Owner: SENTINEL DEVELOPMENT
Project Name: W. SAHARA AVE. & S. FORT APACHE RD. - Wellington Commercial Center
Sheet Title: SITE PLAN - AREA 'C'

Project No.: **PSC - 1141**

SDR-45538
REVISED

Portion of sheet L2.03,
Landscape Plan

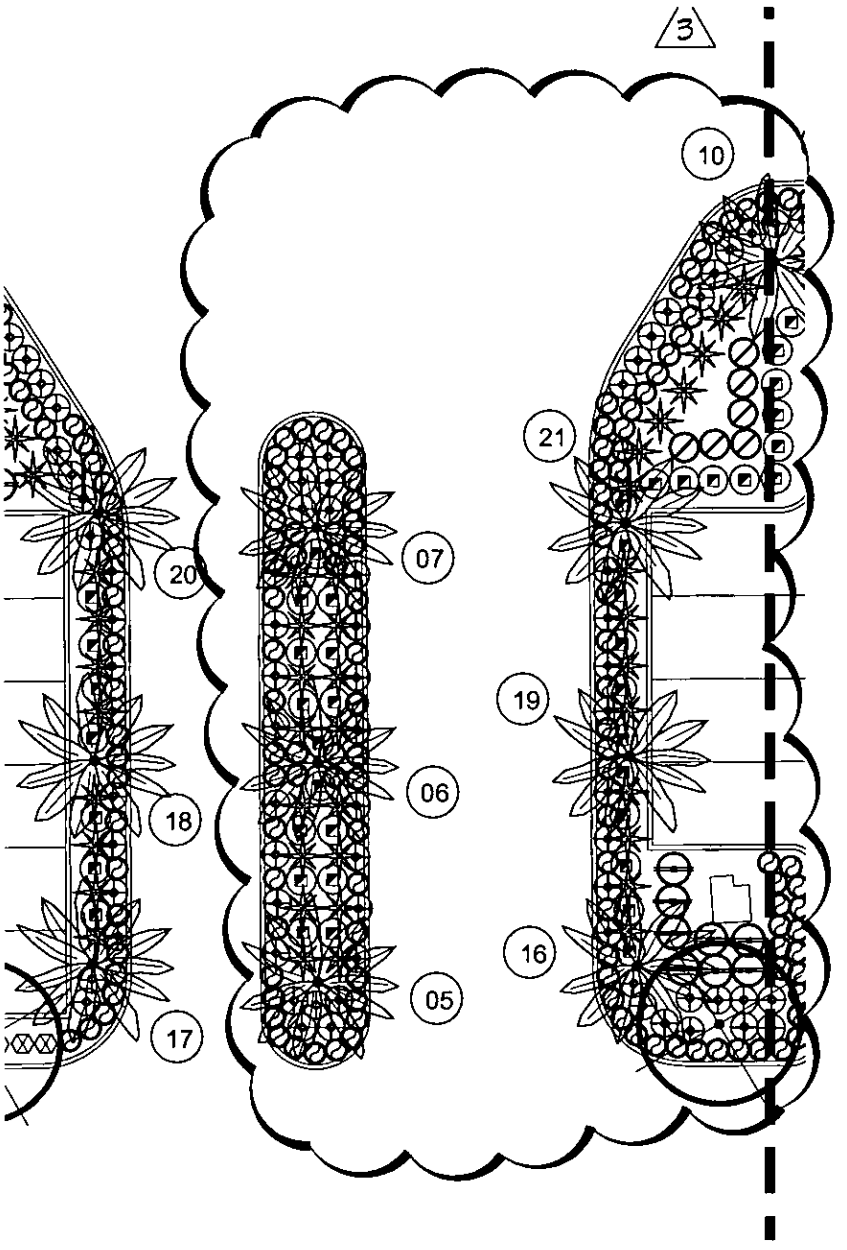
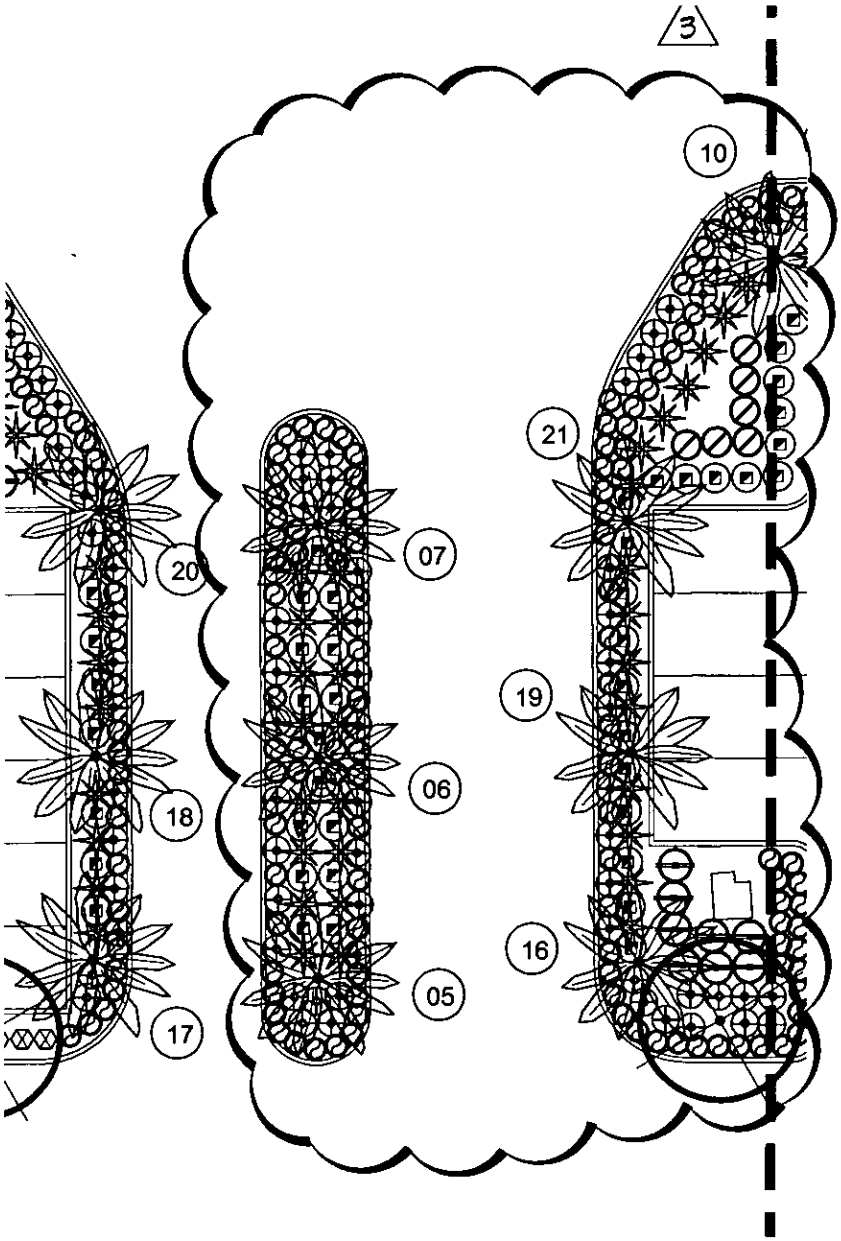
9. As part of our meeting this morning, we discussed the fire department's requirement to widen the ingress/entry lane from Sahara Avenue to 24 feet. This conflicts with the landscape requirements since the islands need to be reduced to accommodate the fire department's request. Therefore, we have added two additional landscape islands to the south of Building 07 in order to offset the amount lost at the ingress/entry drive. Please refer to sheet L2.03 showing the plantings at the new ingress/entry lane and sheets L2.01 & 2.02 for the additional plantings added south of Building 07. These plans are being submitted for your approval prior to our Mylar Express Meeting scheduled for Tuesday, September 11th.

Portion of sheets L2.01 and L2.02

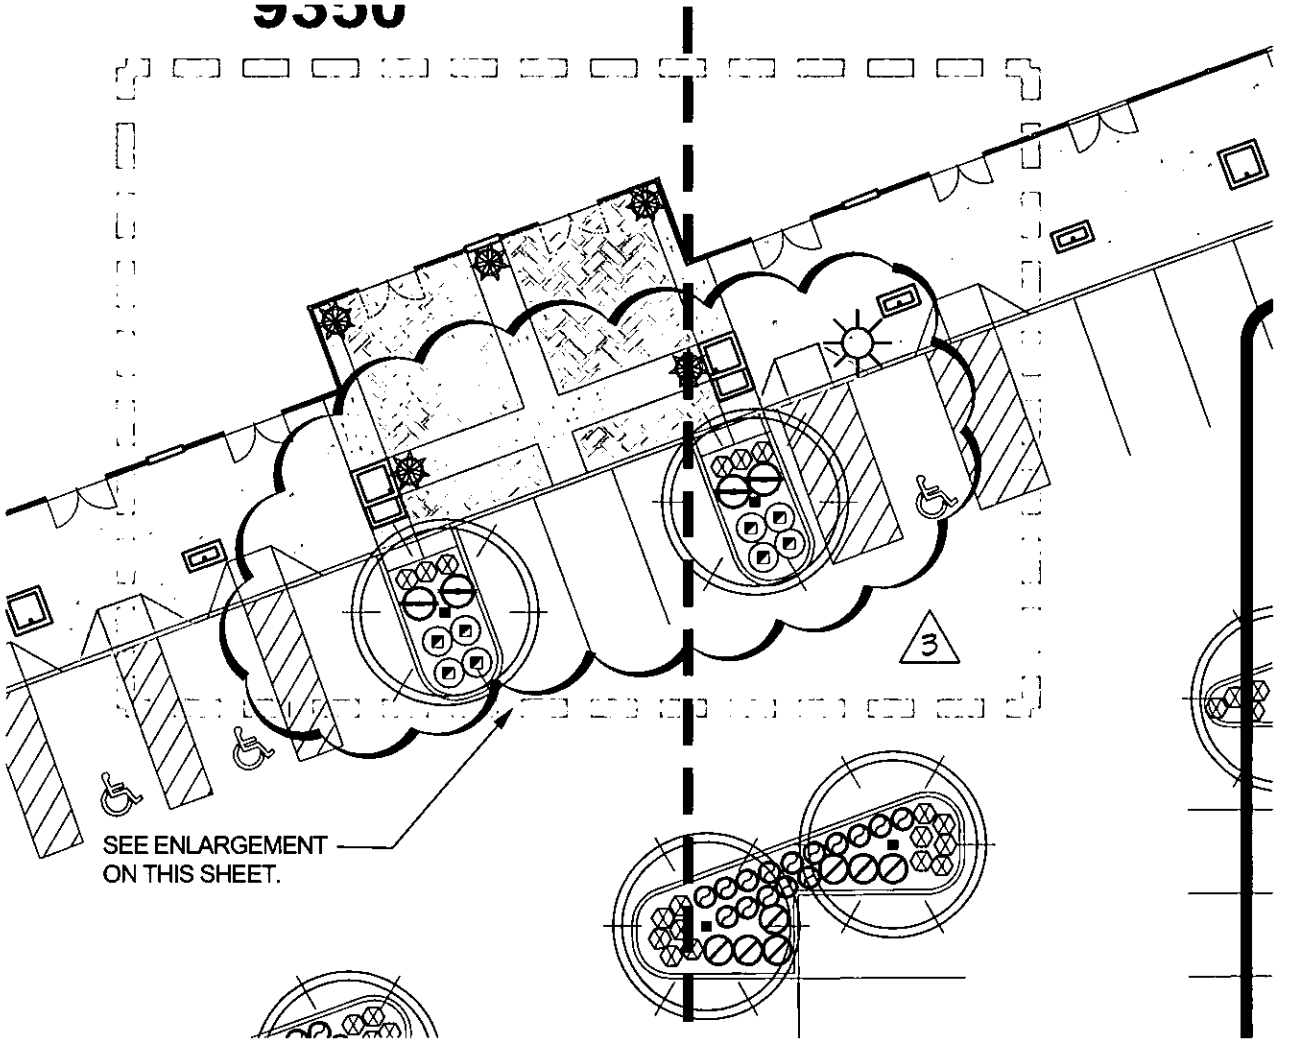
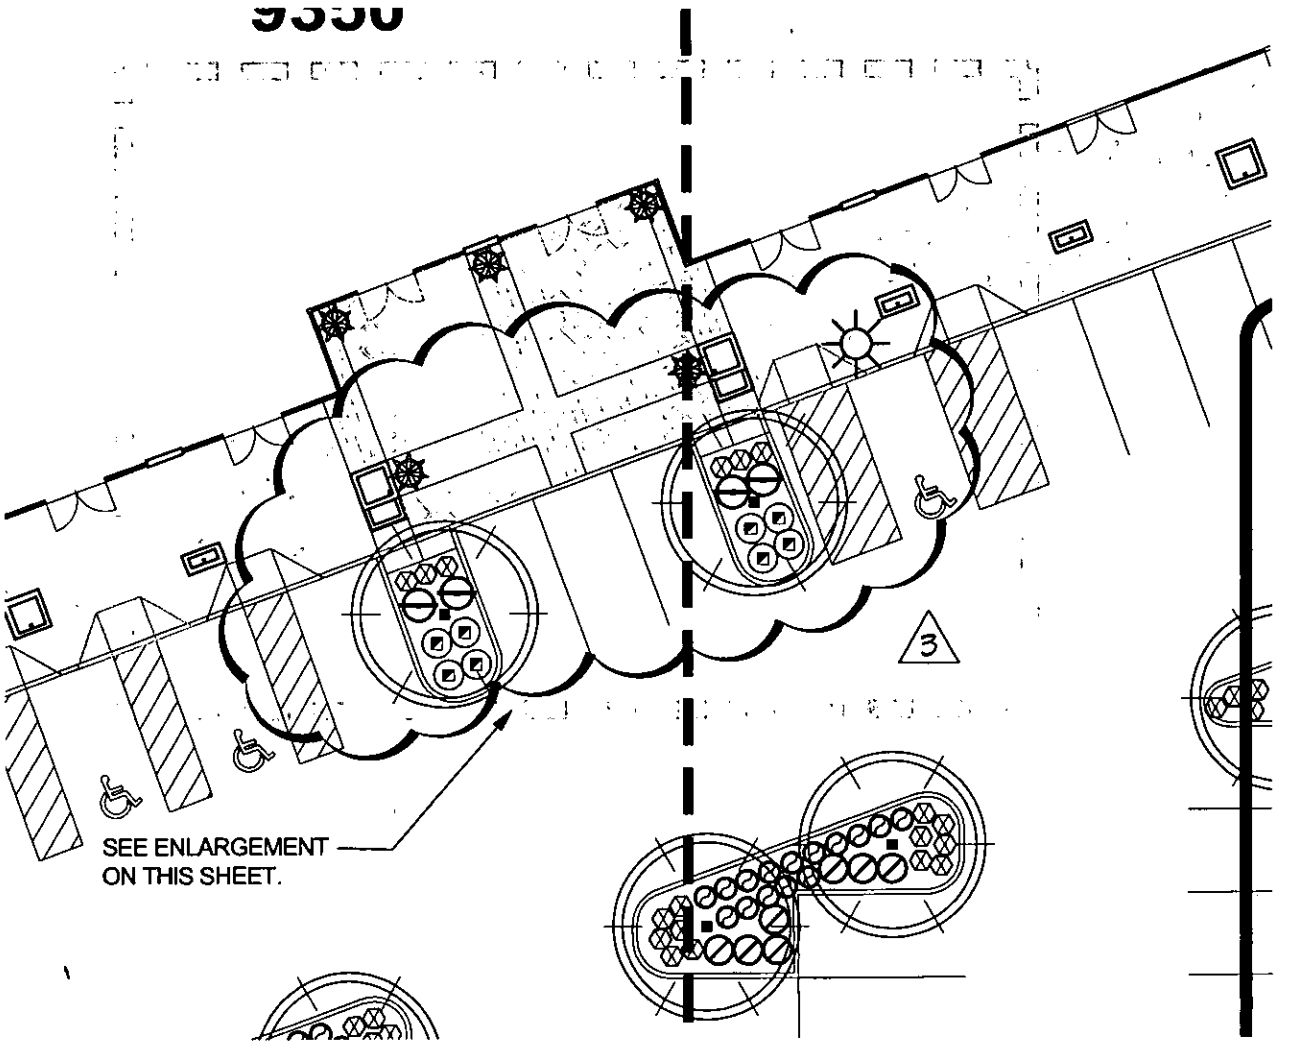
6. Comment:
   Please label the trash enclosure as "Trash Enclosure per Architectural Plans".
   Response:
   This has already been indicated as Note #8 on civil Sheet G-2.
